**FINAL DRAINAGE REPORT  
FOR  
FOUNTAIN VALLEY SALVATION ARMY  
208 CUNNINGHAM DRIVE  
COLORADO SPRINGS, CO 80911**

**June 2, 2022**  
**Revised: December 13, 2024**

PCD Filing No.: CRD242

**SPILLWAY CROSS SECTION  
SECTION  
N.T.S.**

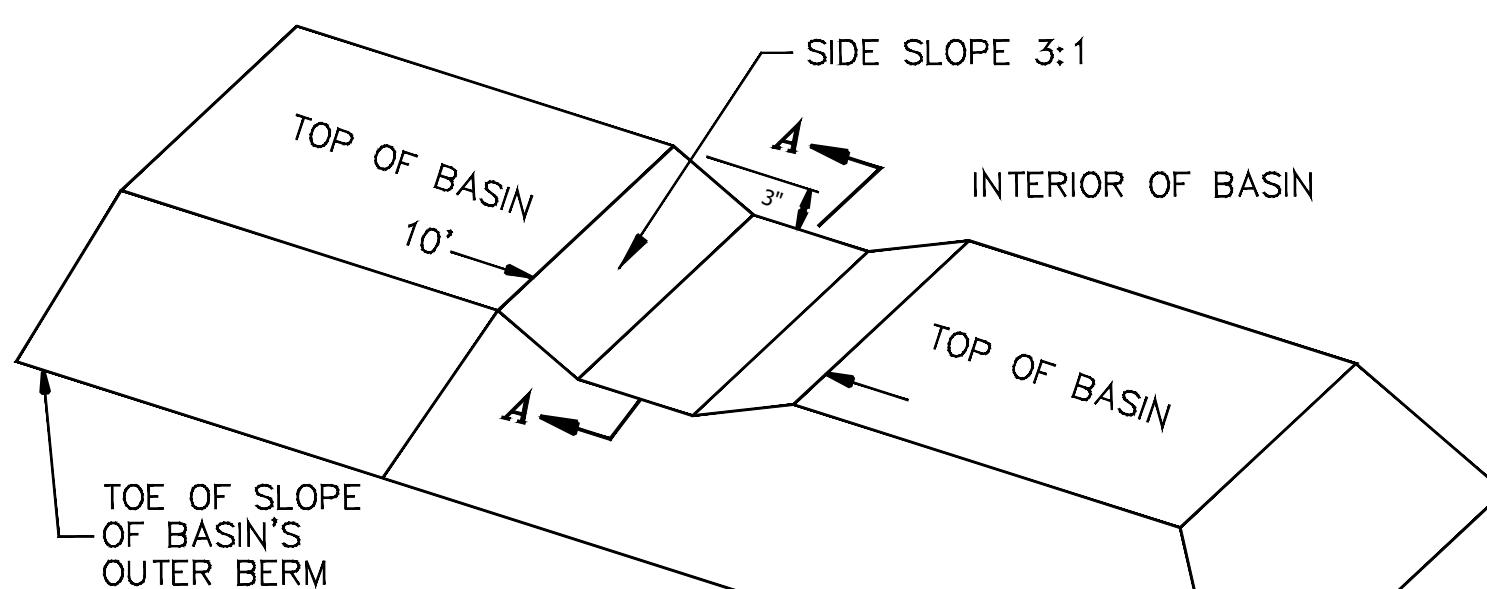
provide calcs for the design of the spillway. From V3 to V4, the depth was reduced from 6" to 3" but the width remained 10ft. Need to see calcs to verify flows/velocities are acceptable and that armoring and/or a cutoff wall is not necessary for the spillway.

POST DEVELOPMENT DRAINAGE MAP

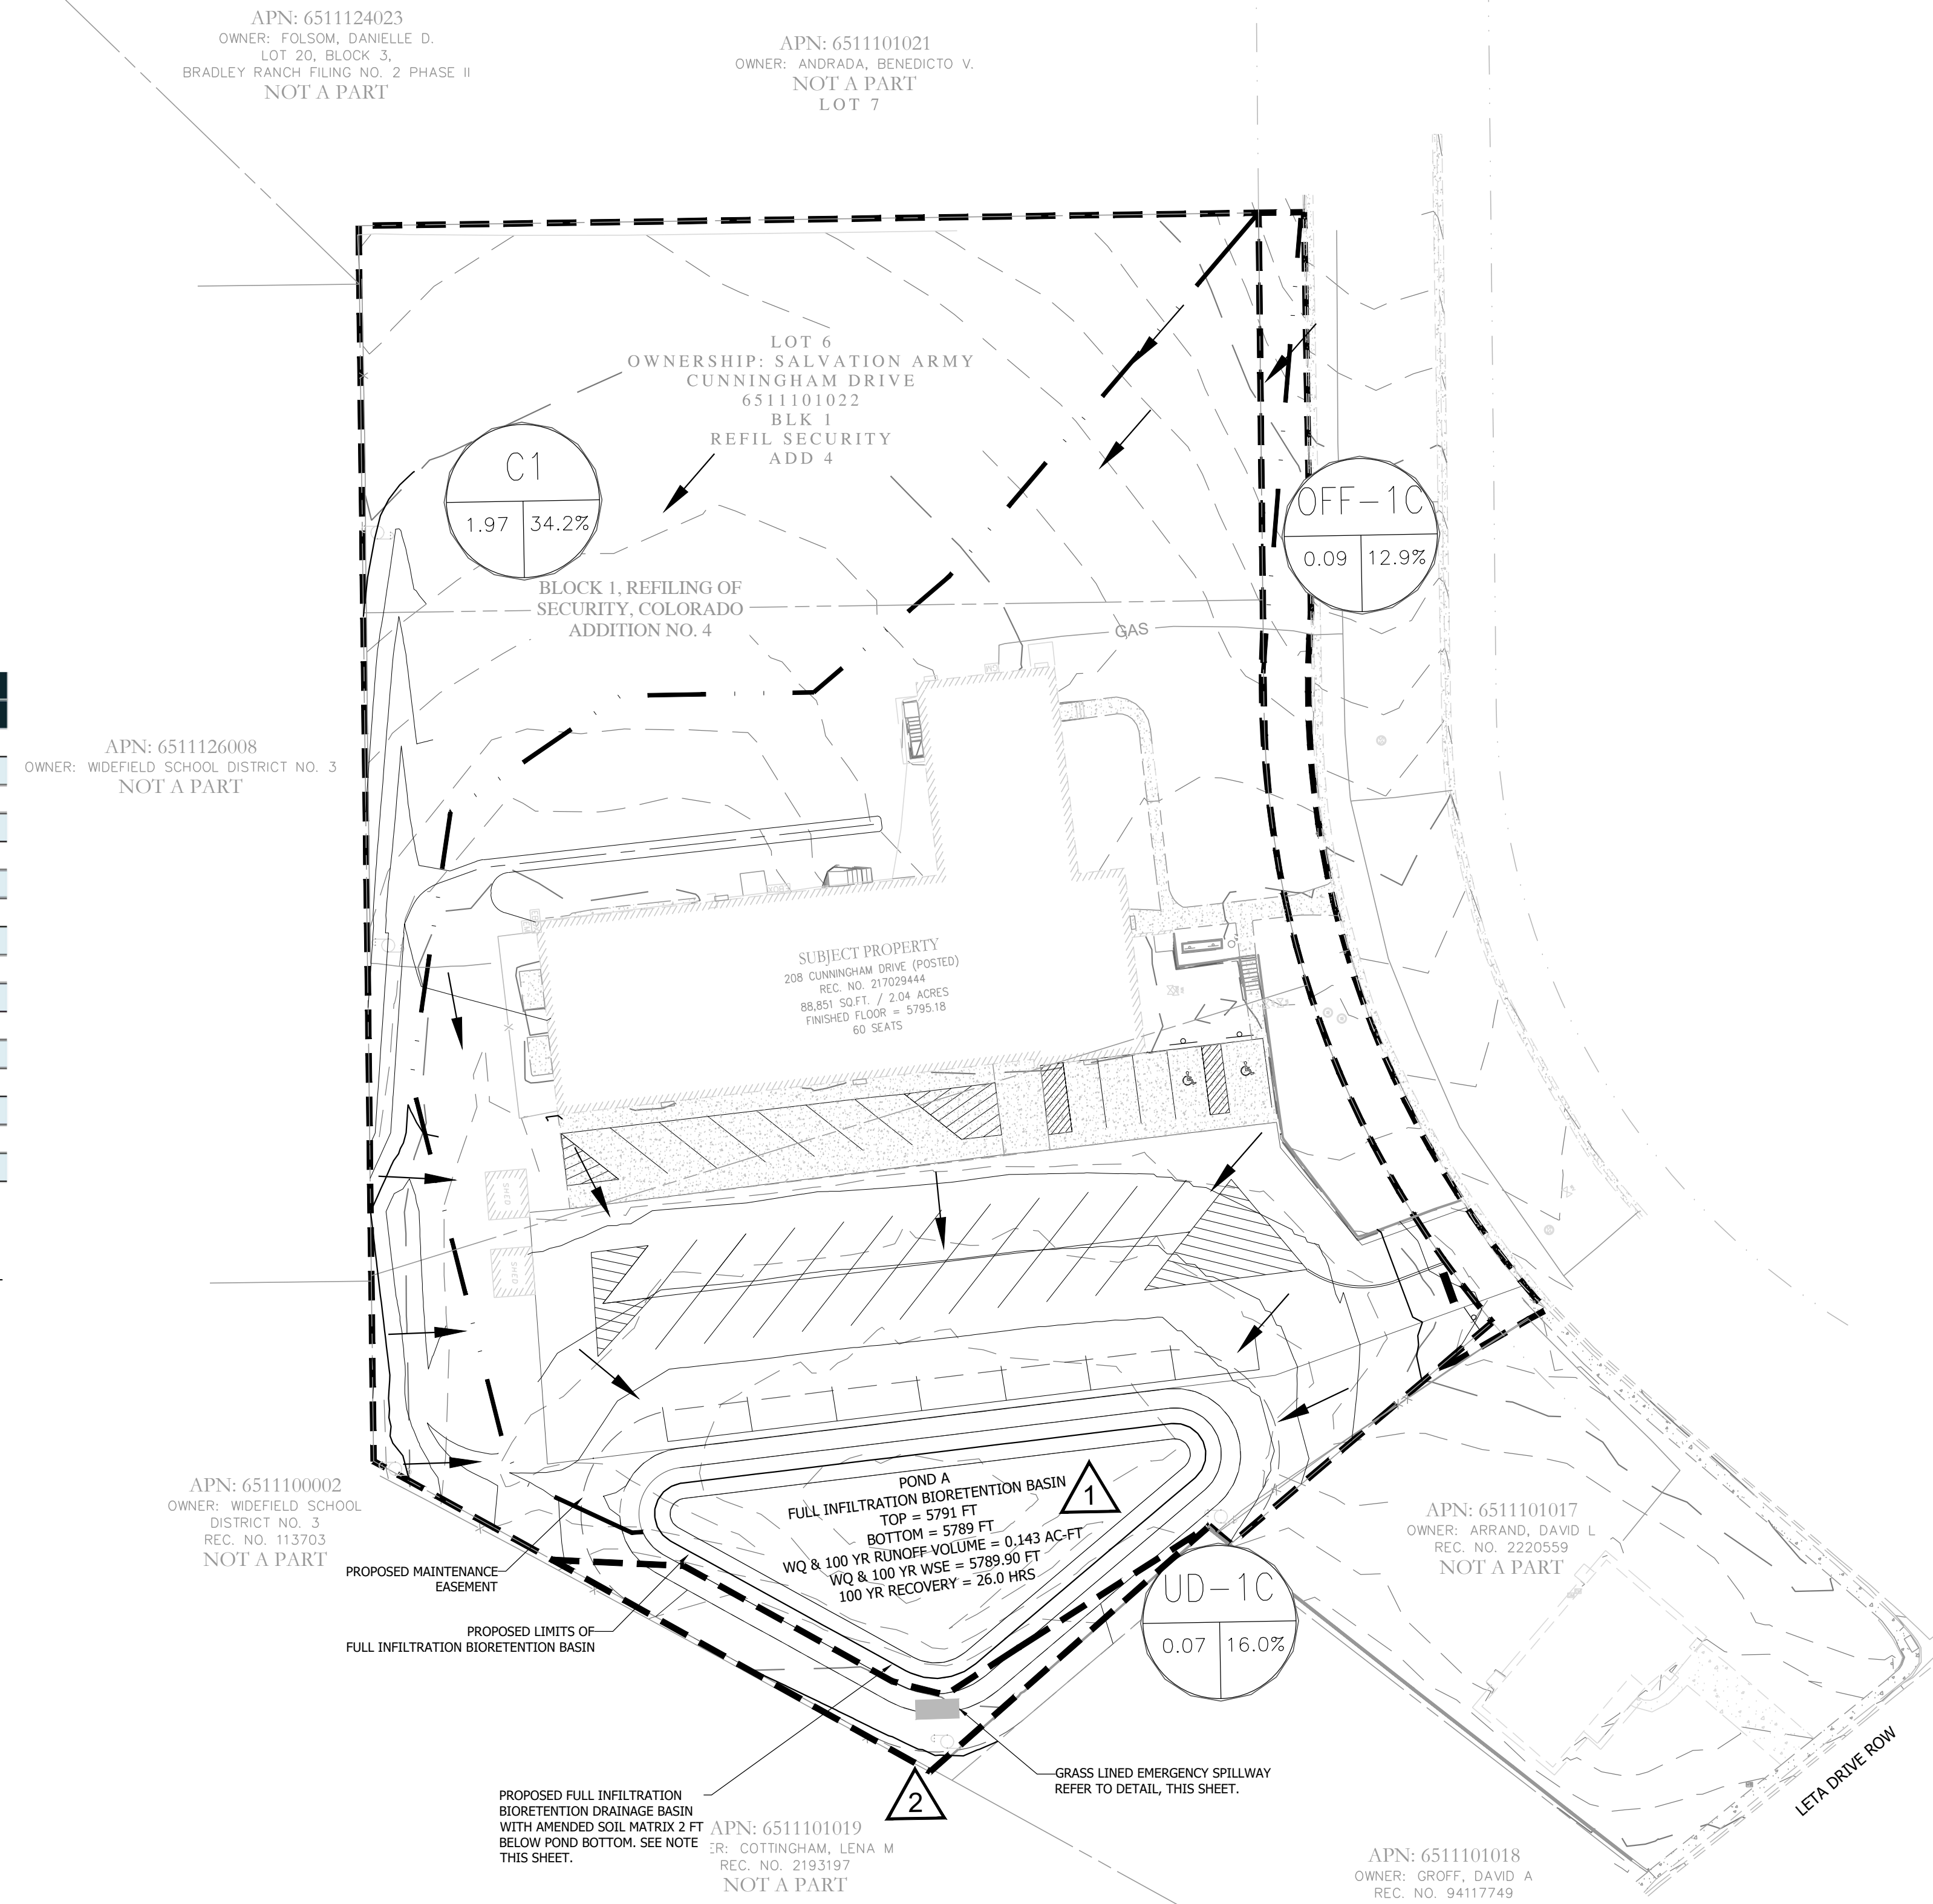
Please add a statement that explains where flow would exit the site if the pond were to over top.
